STAFF REPORT
(Preliminary Plat)

CASE NUMBER: SUB 2011-00045 – LIES SQUARE ADDITION

SUB 2011-00045 – Preliminary Plat of LIES SQUARE ADDITION
October 13, 2011 - Page 2

VICINITY MAP

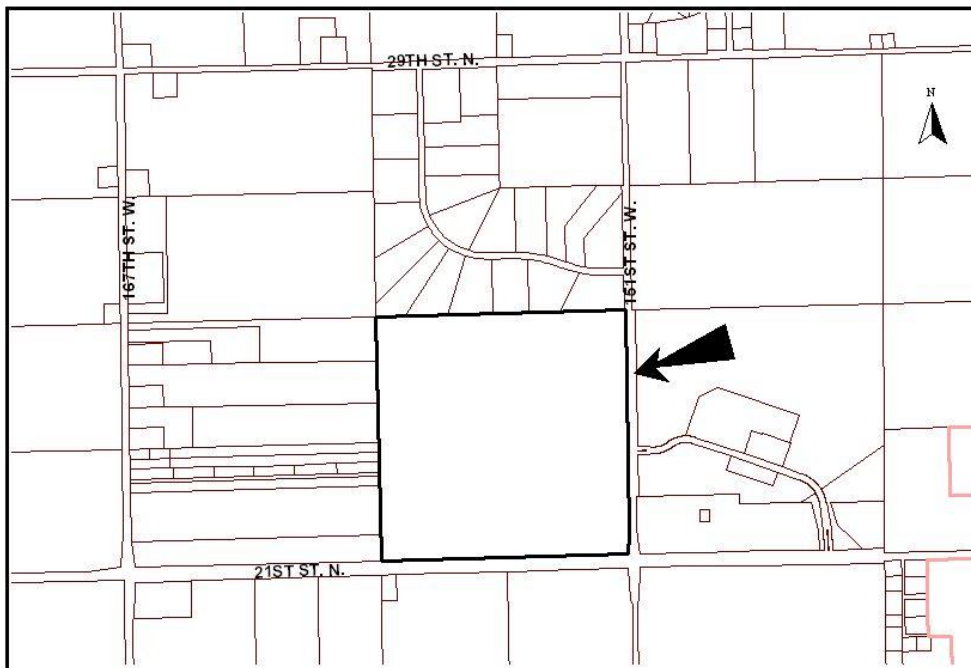
- K. The location map depicting "T26S-T27S" needs corrected.
- L. "Sedgwick" needs spelled correctly under the Benchmark #1 description.
- M. A right-of-way dimension is needed on 151st Street aligning with the south line of Lot 12.
